ADDENDUM No. 2 TO THE CONTRACT DOCUMENTS

Project: City of Unalaska Port Lighting Upgrades

Addendum Issue Date: April 9, 2014

**Spit Dock Drawing for
Response to Question #5**

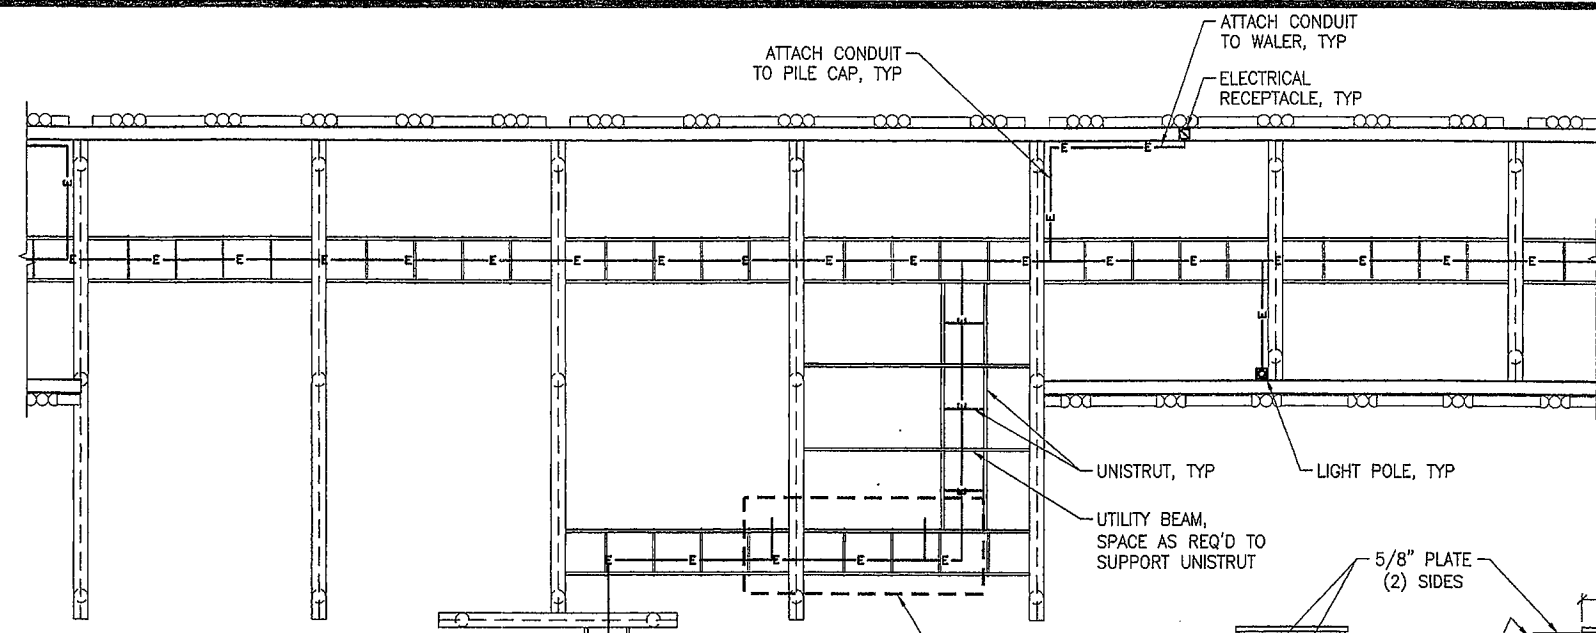
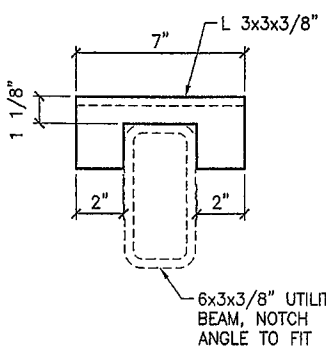
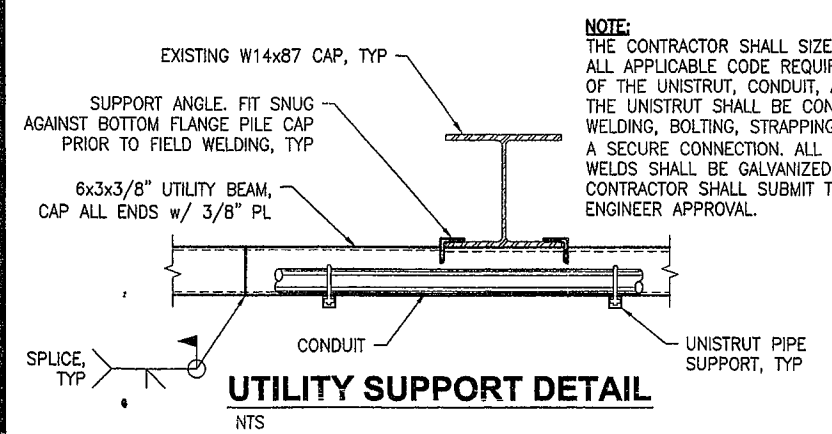
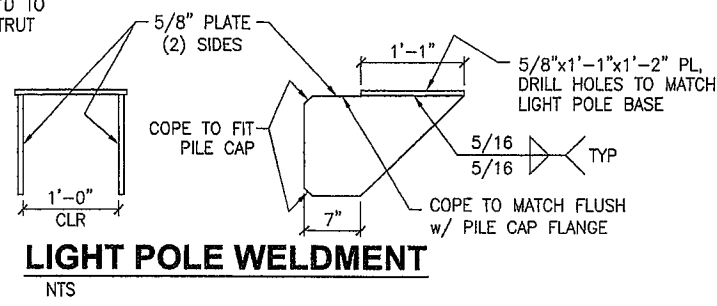
Q5: On Spit Dock Plan Sheet 5, what is the existing wiring method from the Electrical Connex to the 30-ft poles? What is the provision for wire ways in the dock structure?

A5: Electrical conduit runs underneath the existing dock structure and is supported by Unistrut. See supporting drawing attached to this addendum.

TITLE: **SITE PLAN**
SPIT DOCK

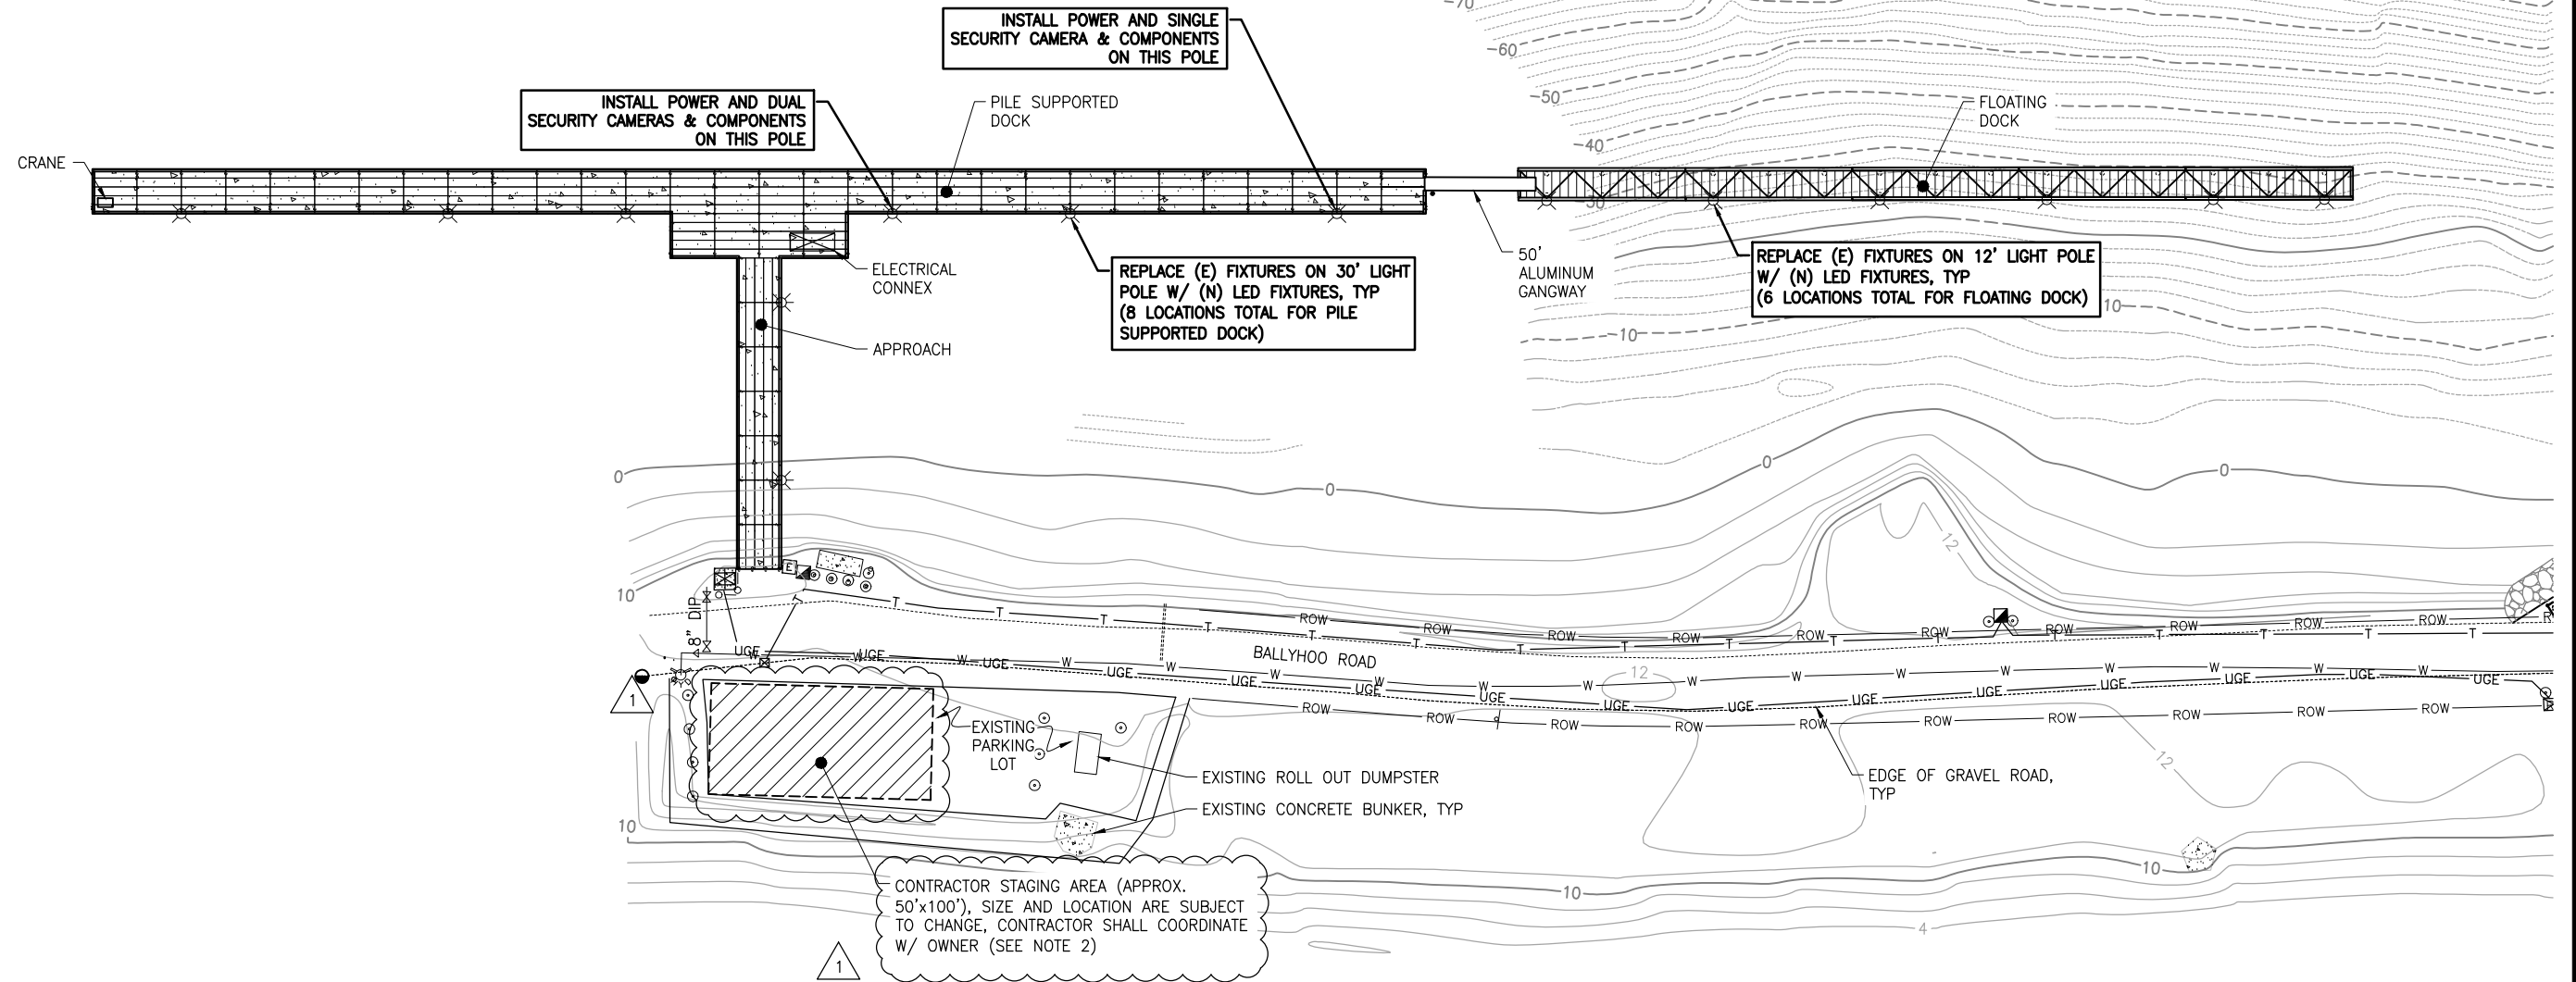
- 3.1 Contractor staging area (approx. 50-ft x 100-ft) has been added to the drawing across Ballyhoo Road from the entrance to the Spit Dock approach. Attached to this addendum is a revised version of the drawing.

**UMC CITY DOCK
HIGH MAST LIGHT ELEVATION**
NTS

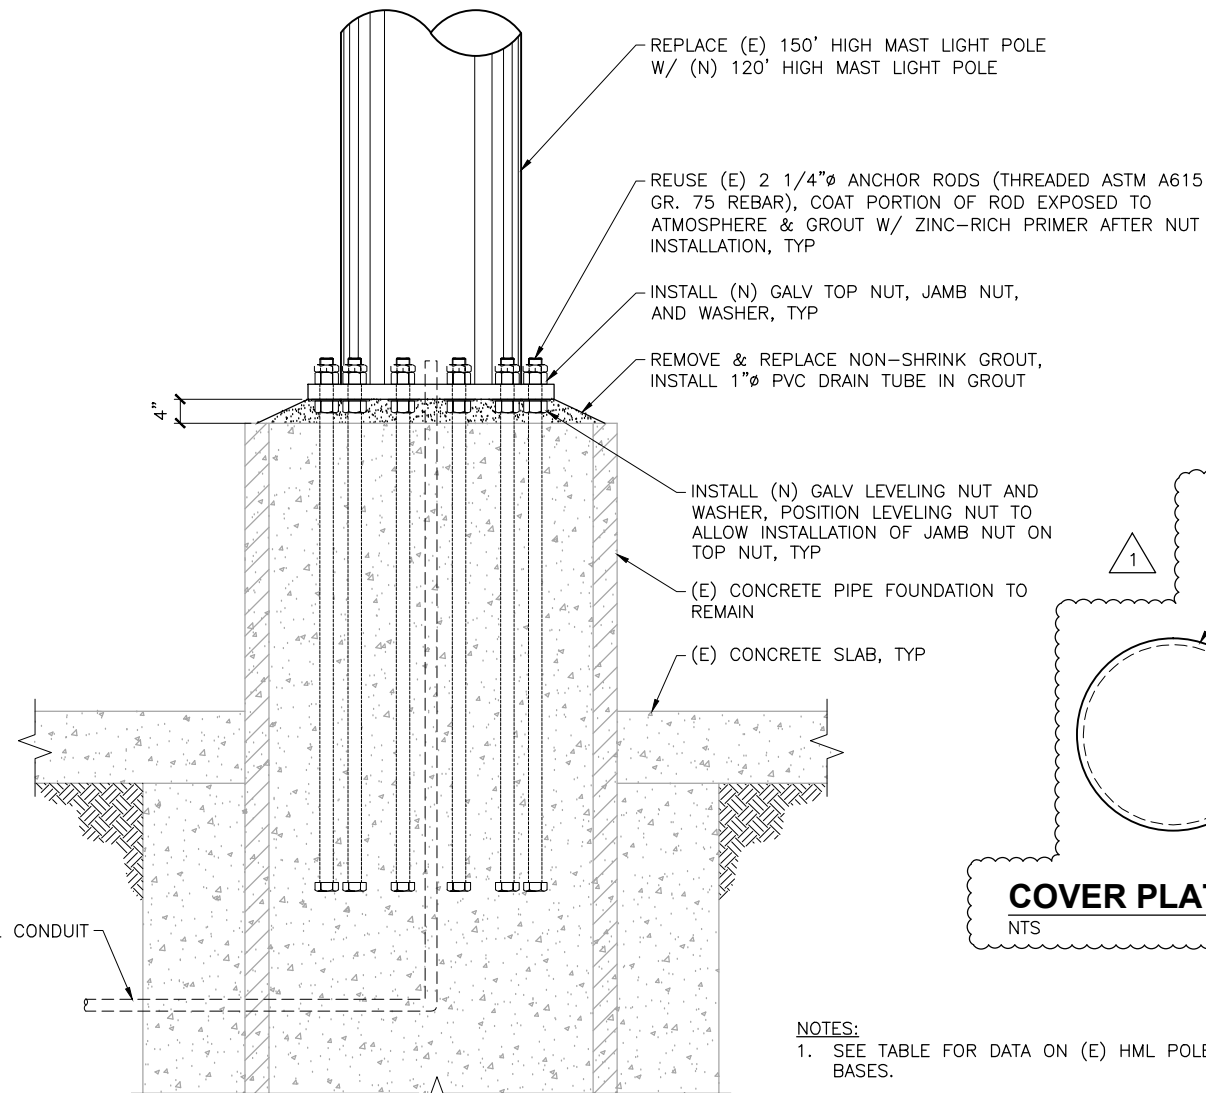
Q3: On Plan Sheet 6, detail “UMC City Dock High Mast Light Elevation” calls for jamb nuts to be installed over heavy hex top nuts. Project photos for UMC City Dock South and North pole locations show a single nut and flat washer on each anchor bolt. There does not appear to be sufficient room to install a jamb nut on exposed threads. In addition, suppliers inform us that 1/2 thickness jamb nuts are not available that meet ASTM 563DH. All other poles in the project have double top nuts and carry ASTM ratings. It is unclear if there is sufficient room to lower the leveling nuts to allow for installation of the jamb nut. If there had been, most likely the existing installation would have double top nuts. Please clarify bolting details for UMC City Dock north and south pole bases.

A3: The elevation of the new poles is being lowered by reducing the thickness of the grout pad to 4”. Based on field measurements, this should be enough to allow the installation of jam nuts on top of the regular nuts. If, however, jam nuts are not able to be installed in the field, use of a thread-locker compound (such as LOCTITE 277) would be required for the regular nuts. If jam nuts are not available that meet ASTM A563DH, jam nuts meeting ASTM A194 Gr. 2H or even a lower standard would be an approved substitute, as the jam nuts are not considered structural.

**UMC USCG DOCK & LIGHT CARGO DOCK
HIGH MAST LIGHT ELEVATION**
NTS

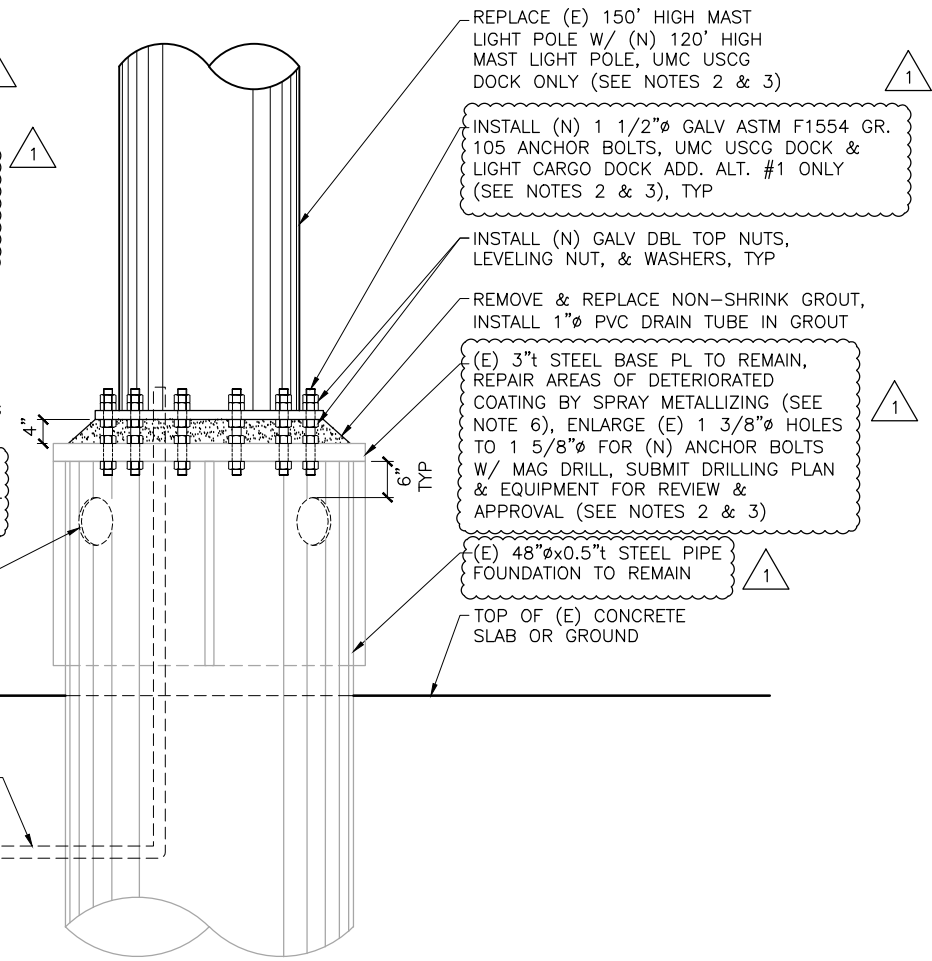
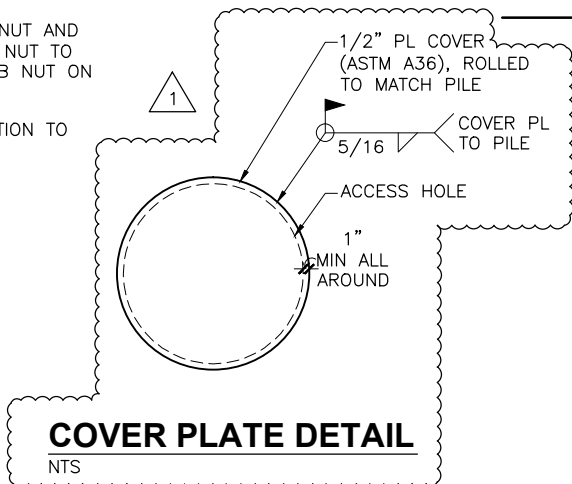
- 4.1 **Clarification:** Changes have been made to the “UMC USCG Dock & Light Cargo Dock High Mast Light Elevation” to show that new anchor bolts/rods are required to be installed at the UMC USCG Dock high mast lights (for Base Bid) and at the Light Cargo Dock (Additive Alternate Bid Item #1 only). The existing anchor bolts/rods will still be reused with the existing high mast light pole at the Light Cargo Dock for the Base Bid.

- 4.2 Anchor bolt call-out changed to require installation of new **1 1/2" dia. galvanized ASTM F1554 Gr. 105 anchor bolts/rods** for the UMC USCG Dock (Base Bid) and Light Cargo Dock (Additive Alternate Bid Item #1 only) high mast lights.

- 4.3 Existing steel base plate call-out changed to indicate that it is **3" thick** and require enlargement of the existing holes in the base plate with a mag drill to accommodate the new anchor bolts/rods that are a larger diameter.

- 4.4 Existing steel pipe foundation call-out changed to indicate that the pile is **48" dia. (outside) x 0.5" thick**.
- 4.5 Call-out added for access holes to be plasma cut in the steel pipe foundation for installation of any new anchor bolts. The access holes are to be covered with a steel plate welded to the pipe foundation after use.

- 4.6 Cover Plate Detail added for UMC USCG Dock and Light Cargo Dock (for when access hole is required for new anchor bolt/rod installation).
- 4.7 The term "**ANCHOR BOLTS**" was added to Note 2.

- 4.8 The term "**1 1/2"φ ANCHOR BOLTS**" was added to Note 3.
- 4.9 Note 7 was added.
- 4.10 Attached to this addendum is a revised version of the drawing.
